CITY OF ALBUQUERQUE

RE: **Global Storage- Coors**
3421 Coors Blvd NW
Grading and Drainage Plan
Engineer's Stamp Date 4/30/18
Hydrology File: G11D071

**RE: GLOBAL STOARGE – COORS
Grading and Drainage Plan (G11/D071)**

CG-101

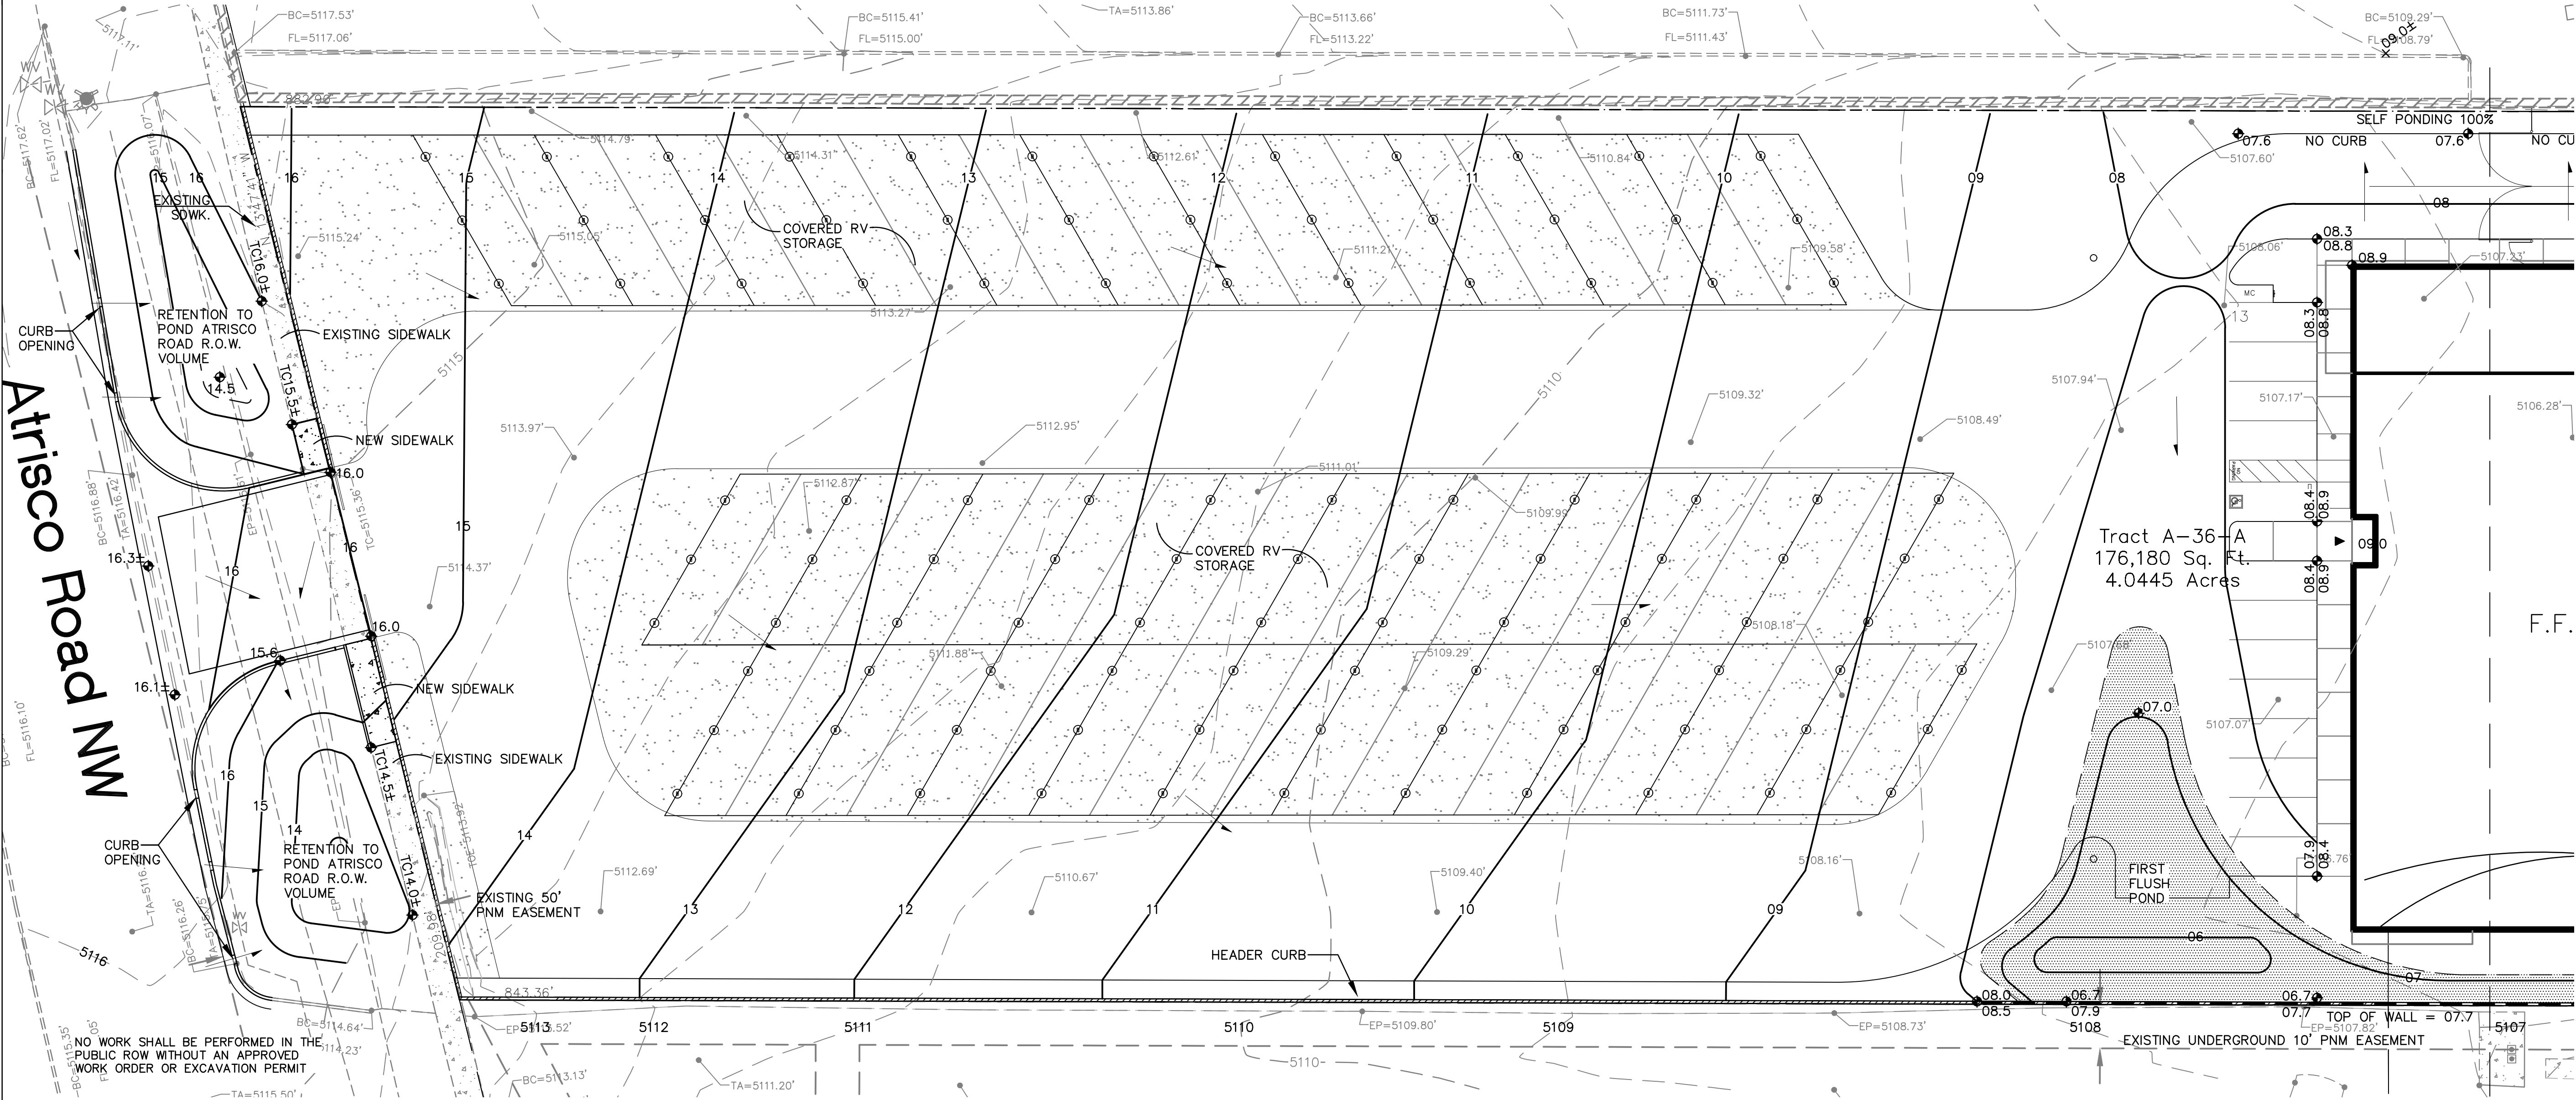
4. Along Atrisco, size the retention areas to be able to pond the portions of Atrisco that drain to them. Since this will all occur within the ROW, a work order, or excavation permit at minimum, will be needed. Also include a 0.87' water block at this drive entrance unless calculations can be provided to support a smaller water block.
5. There appear to be a few areas around the dumpster access where impervious areas are not being retained on-site. Please add detail to show how these areas are being captured. If unable to capture and retain on-site, quantify the first flush bypass volume and state on plans. Payment of fee in-lieu will then be required at building permit.

7. Curb openings and retention will be provided for the portions of Atrisco fronting the property. Notes regarding work in the public ROW (see comment 2).
8. A recorded SIA with financial guarantee will be provided.

CG-102

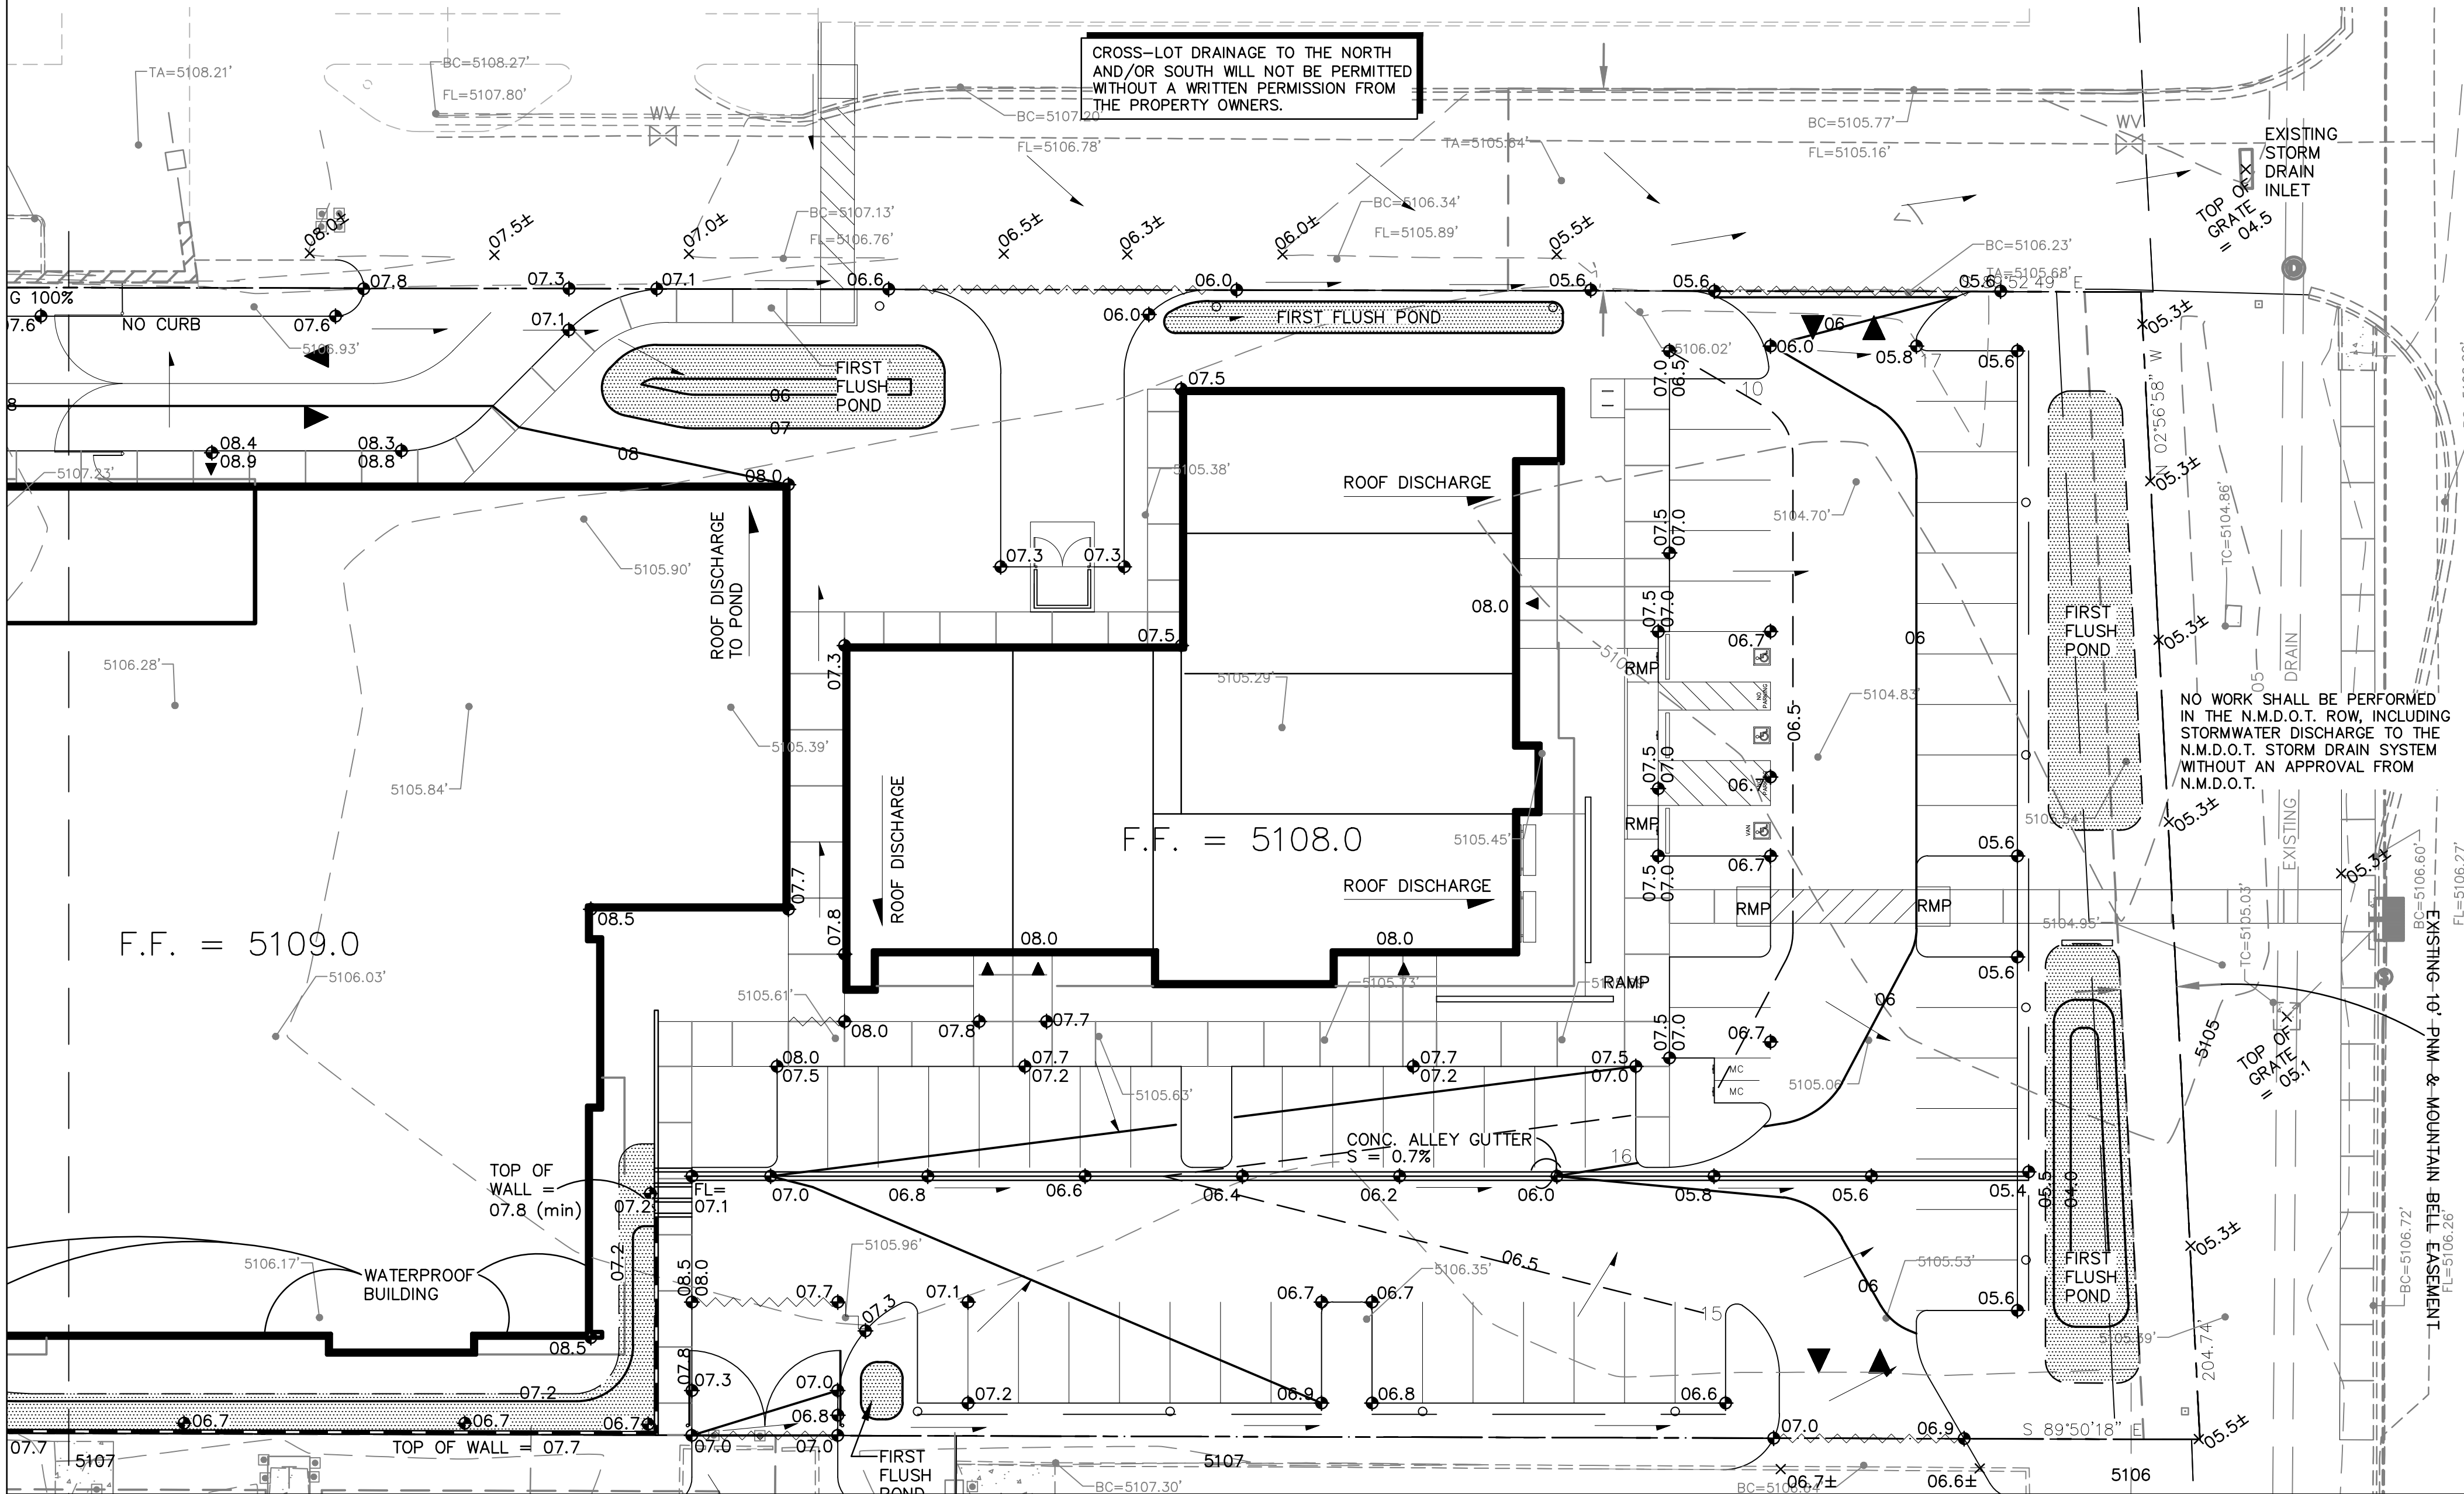
1. Correct the land treatment type for the historic flows; land treatment B is more appropriate for an undeveloped site.
2. Please clarify areas of impervious vs. pervious surfacing. The covered RV storage areas in Basin 1 need to be assessed as impervious area for your developed conditions flow.
3. The detention ponds along Coors need to be sized and shown on this plan, as well and their outfalls (orifice plates). Additional details can be shown on the building permit plan.

6. Areas of impervious vs pervious surfacing is clarified on the CG-102 exhibit and as shown below (impervious is unshaded.) The final building permit submittal will update impervious / pervious area calculations.

The following note has been added to the plans: “For the building permit submittal, all drainage sub-basins and the associated first flush pond volumes will be clarified to ensure all impervious surface first flush discharge is retained.”
